**LICENSE SUA-1341
DOCKET NO. 40-8502**

**Subject: SERP Summary - Revised Replacement Pages for the 1996 License
Renewal Application**

Pages 3-37, 5-2 through 5-4 and 6-8 through 6-9A.

Christensen Ranch Project

SATELLITE PLANT GENERAL ARRANGEMENT DIAGRAM

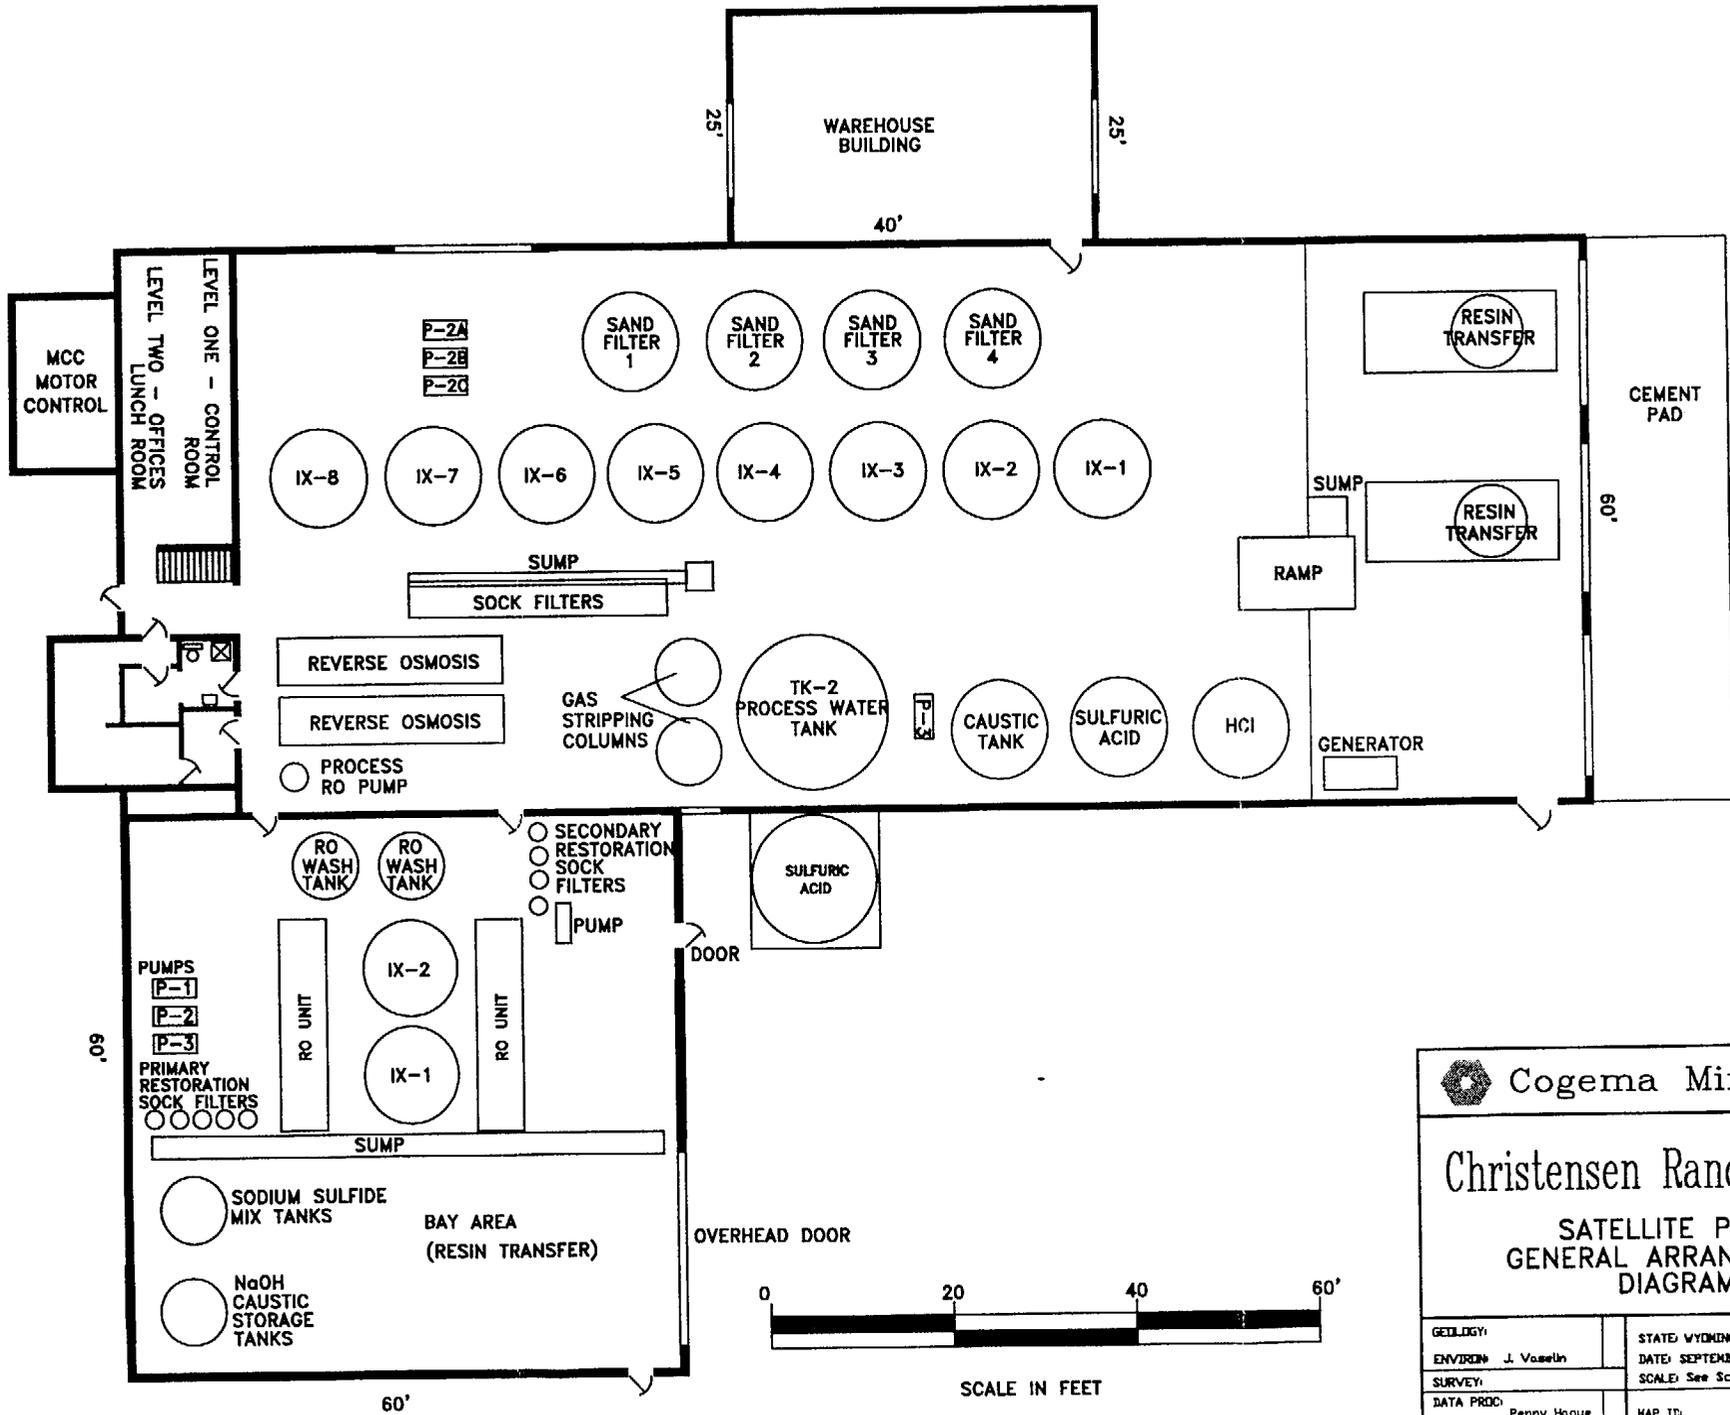
GEOLOGY:	STATE: WYOMING	COUNTY: JOHNSON
ENVIRON: J. Vasselin	DATE: SEPTEMBER 1995	
SURVEY:	SCALE: See Scalebar	REVISED: 2-NOV-01
DATA PROD: Penny Hogue	HAP ID:	Figure 3.11

FIGURE 5.1

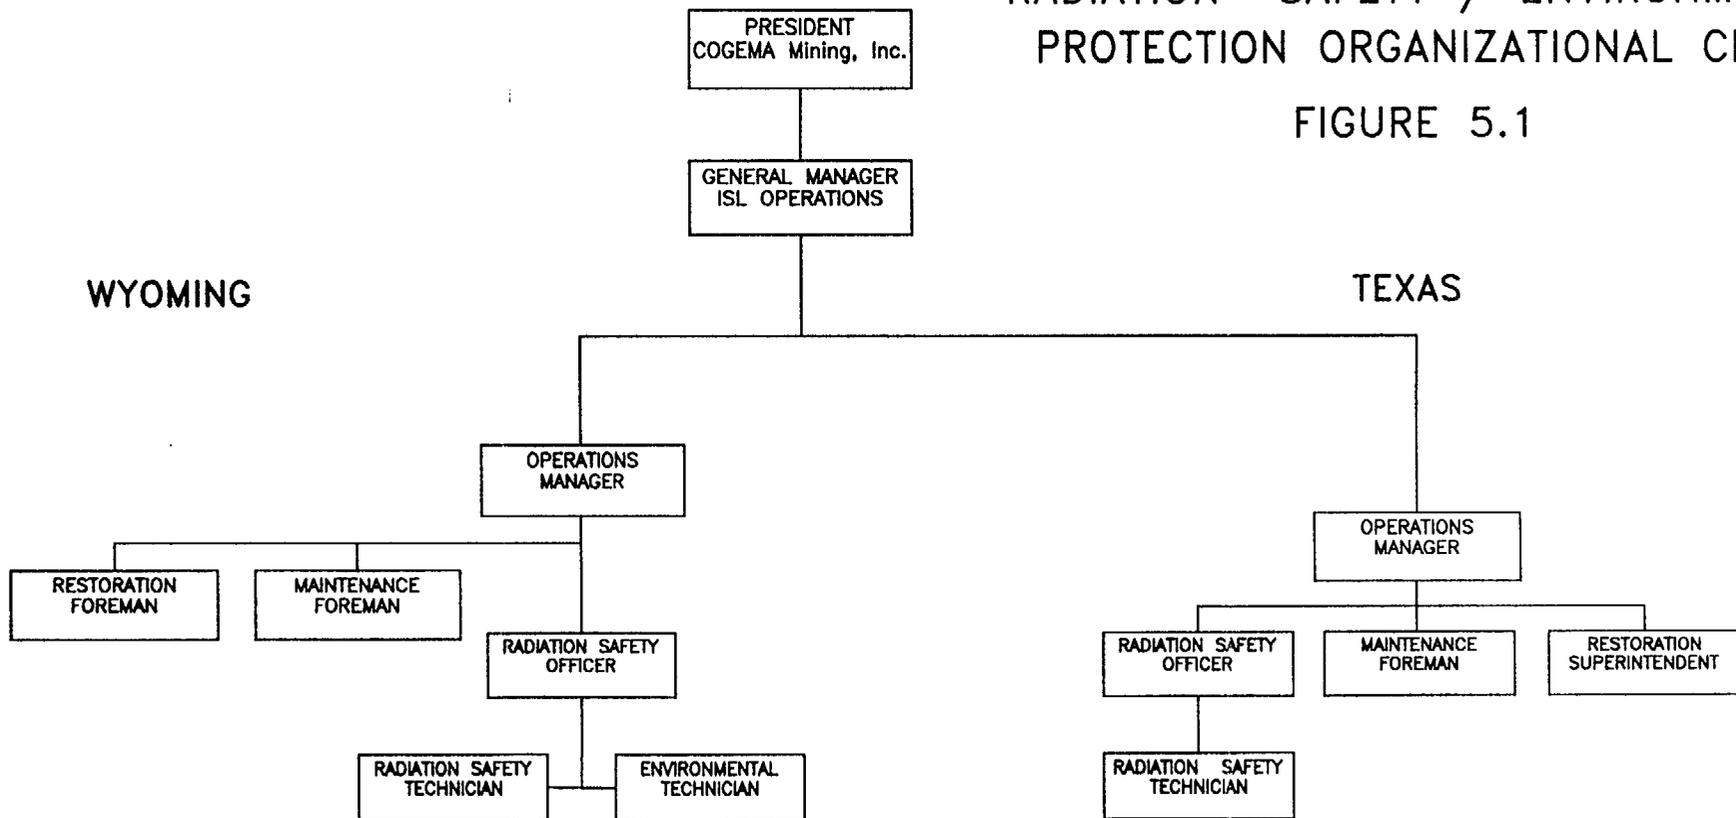
Revised 1/20/2001
